Arlington Zoning Board of Appeals

Docket # 3719: 1021-1025 Massachusetts Avenue

Re: Tetra Tech Comment Letter 2
Comprehensive Permit (40B) Peer Review
1021-1025 Mass Ave
Arlington, Massachusetts

PLANTING PLAN

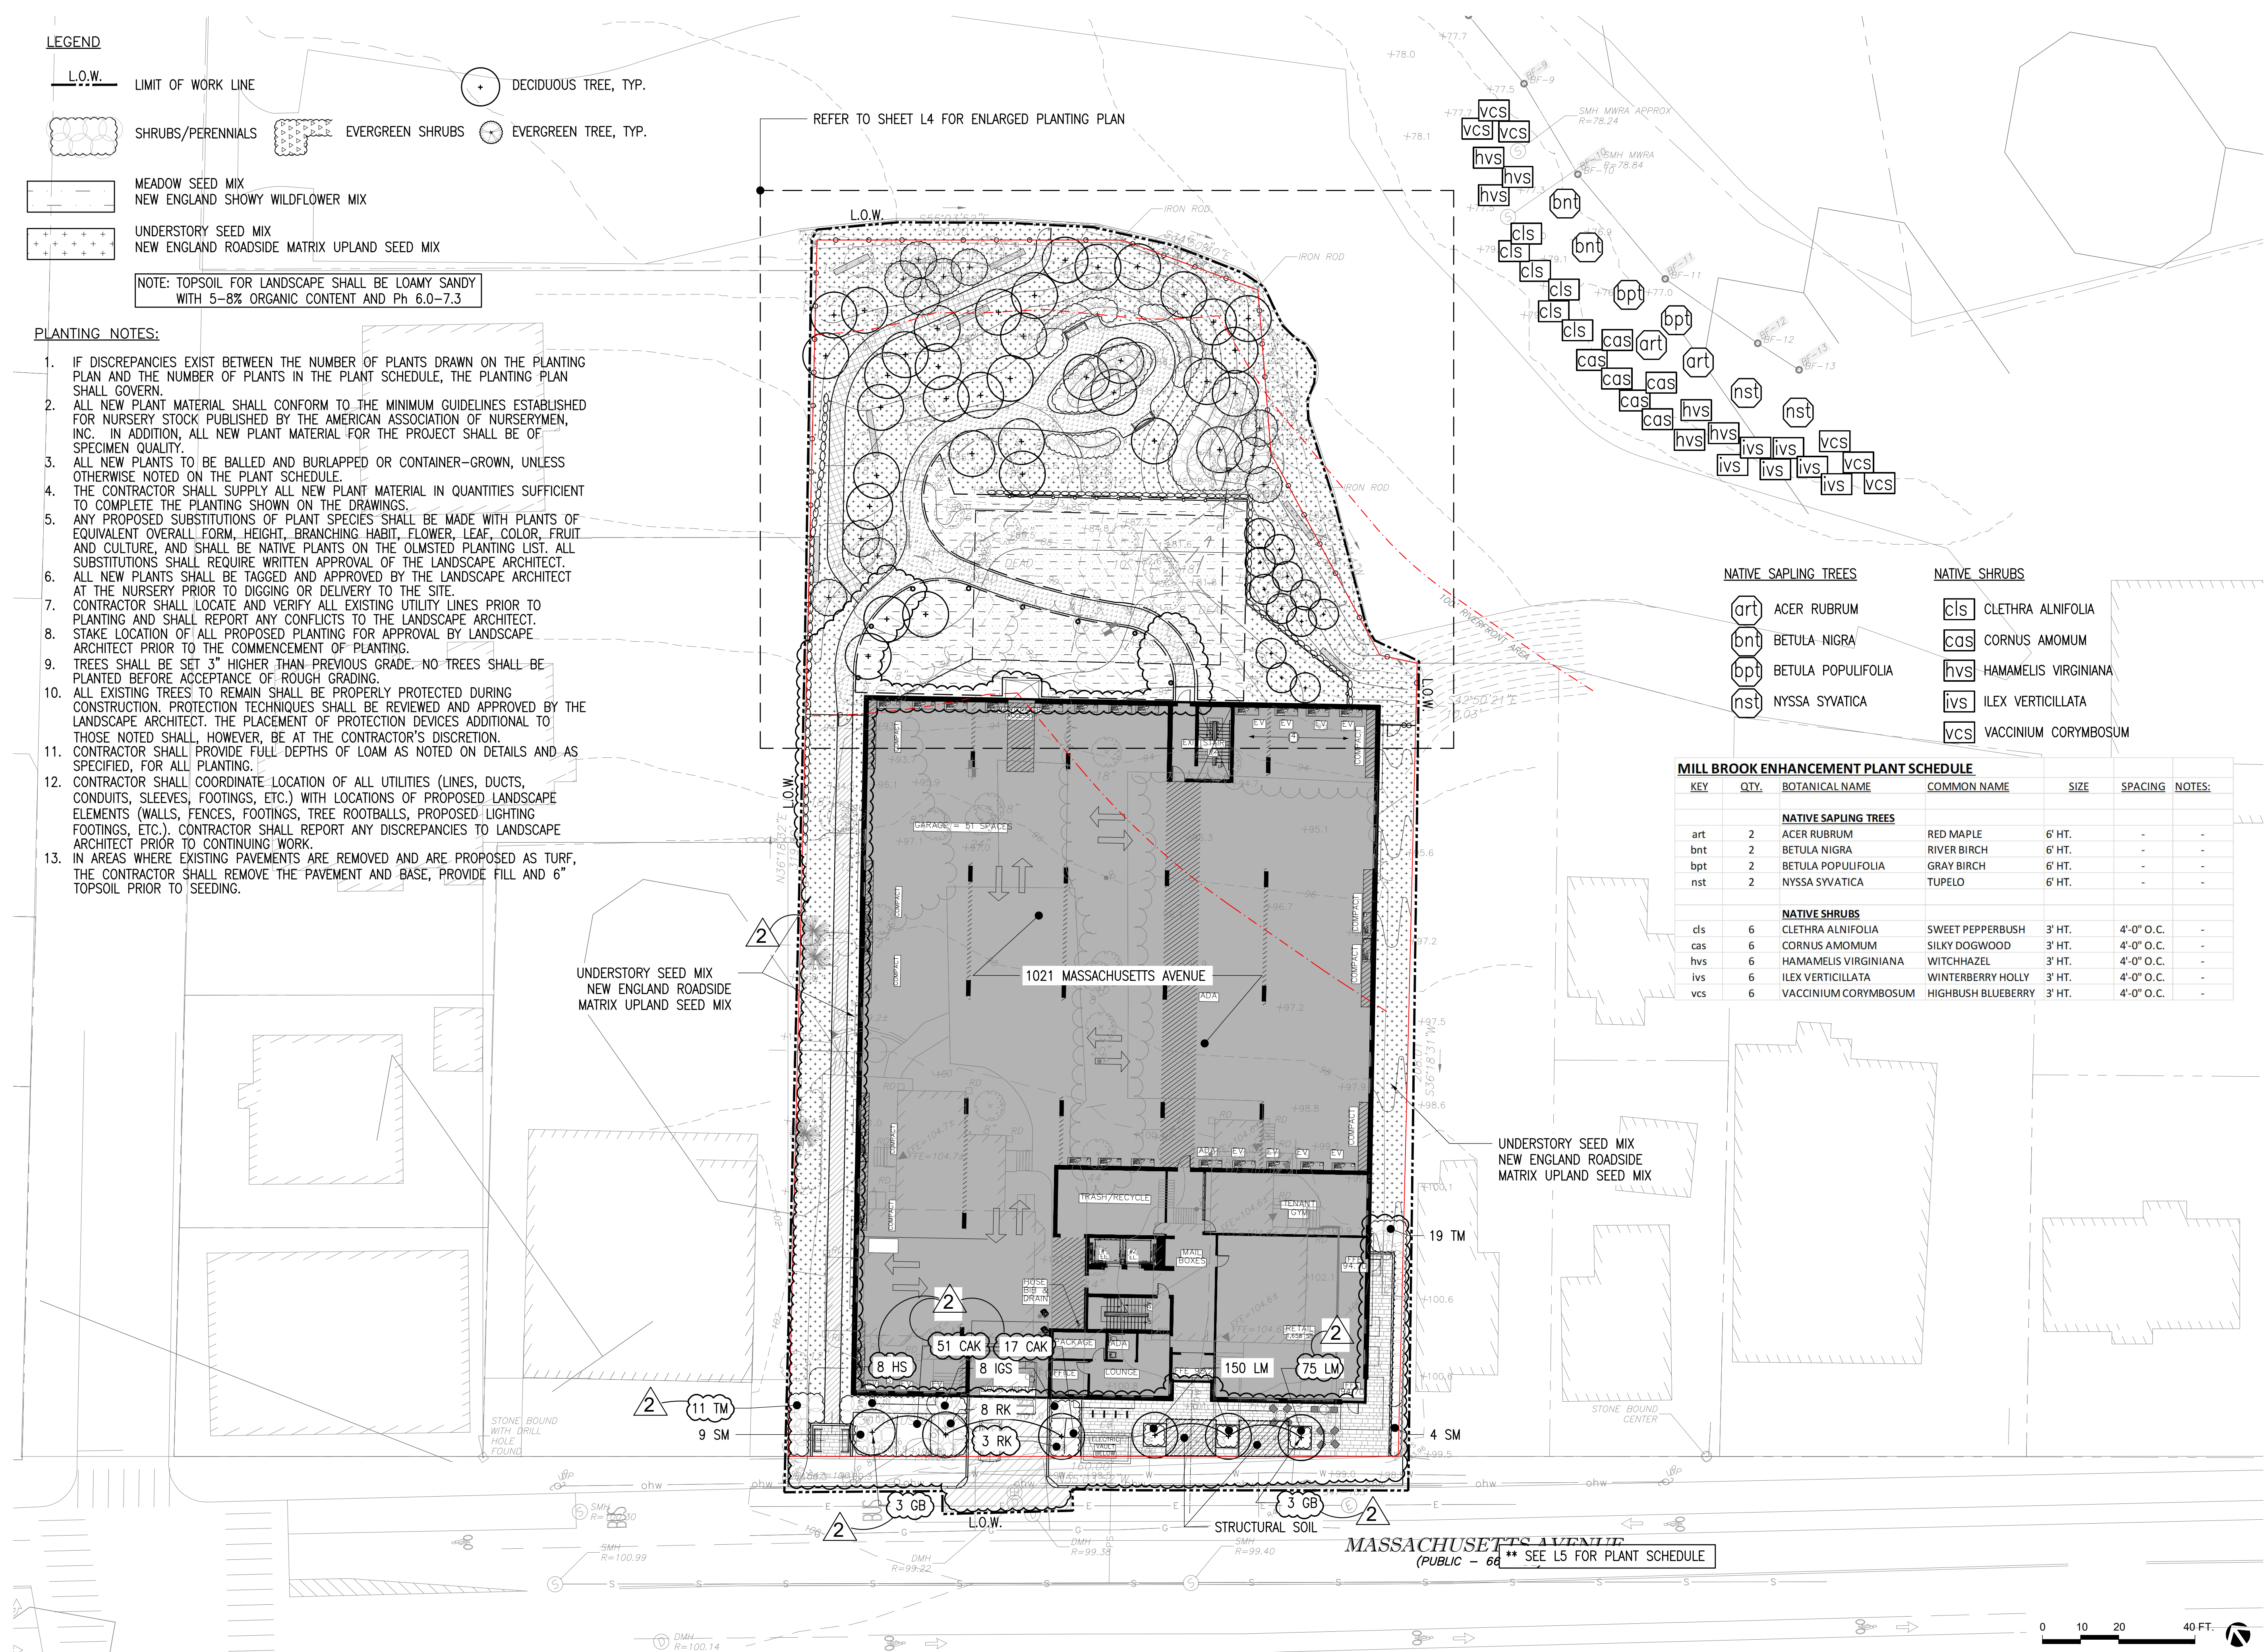
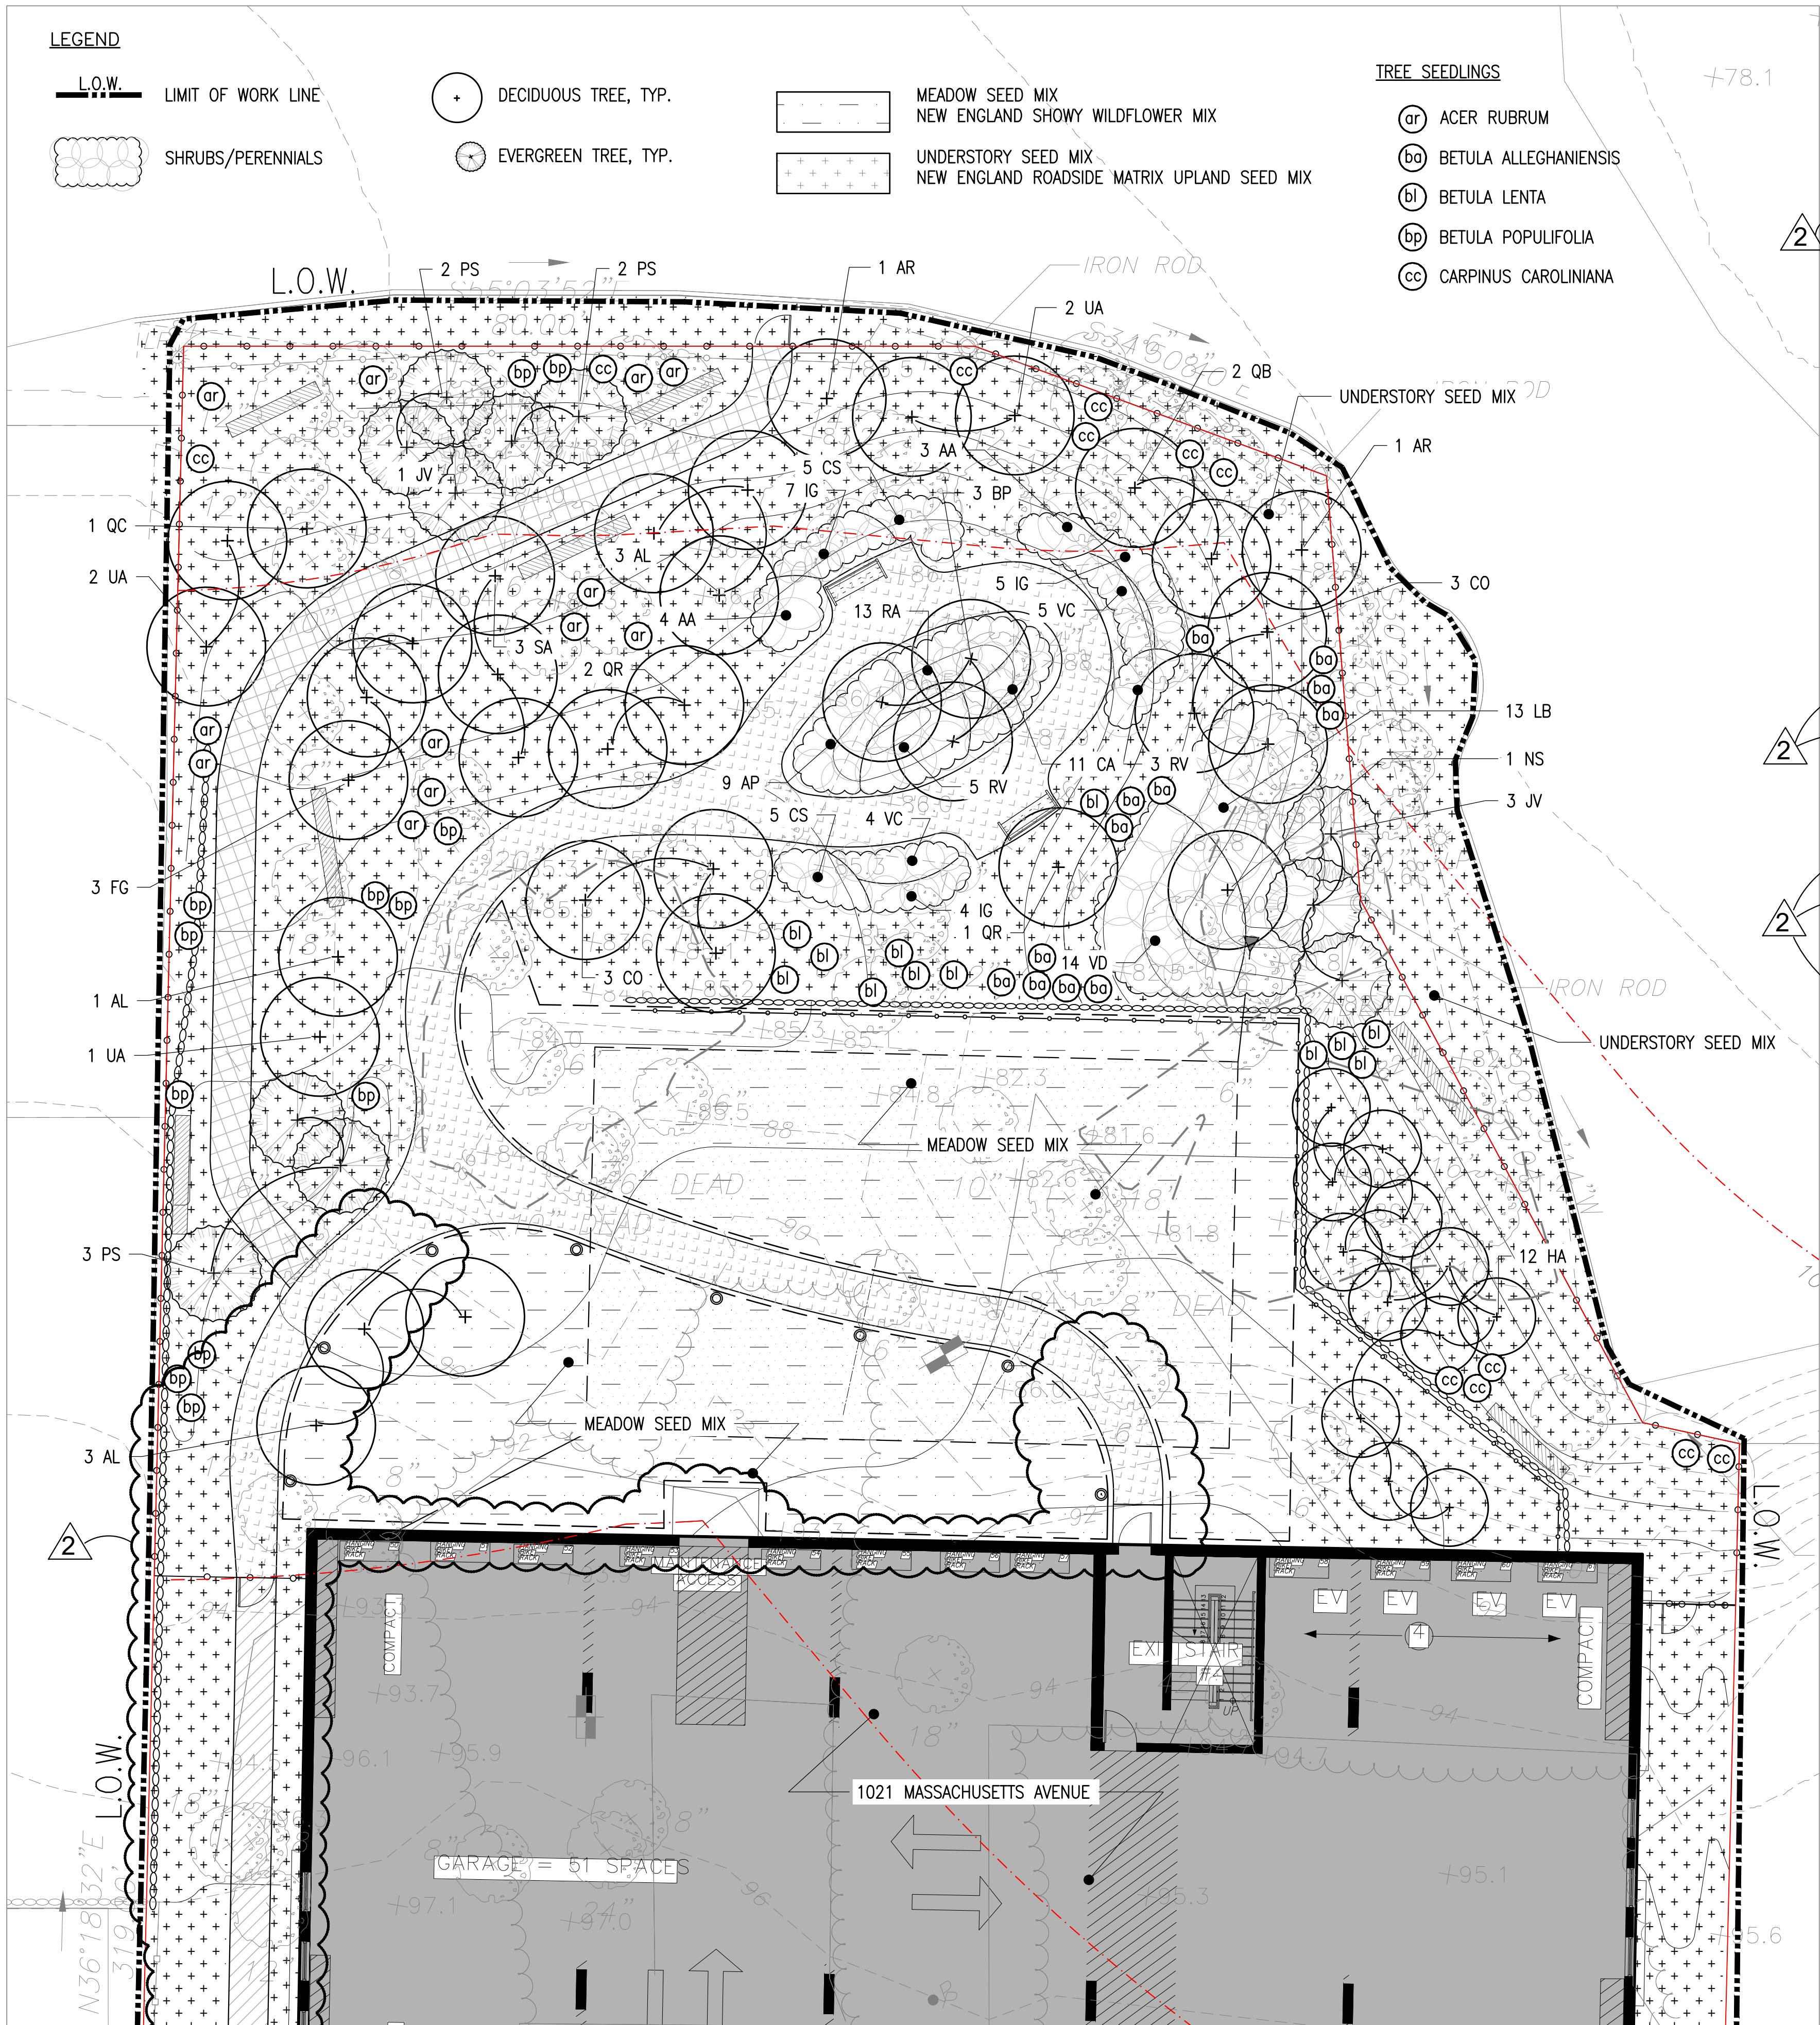
46. The Planting Plan indicates several new trees will be planted in the northern portion of the site. Please confirm if the Planting Plan contemplates infilling among the existing trees. If infill, please distinguish between trees designated to remain in place and those intended to be removed. Suggest any trees scheduled to be removed not be shown on the Planting Plan.

2023-02-17 Update – No response provided however comment has been addressed in revised submittals. **Comment Resolved**
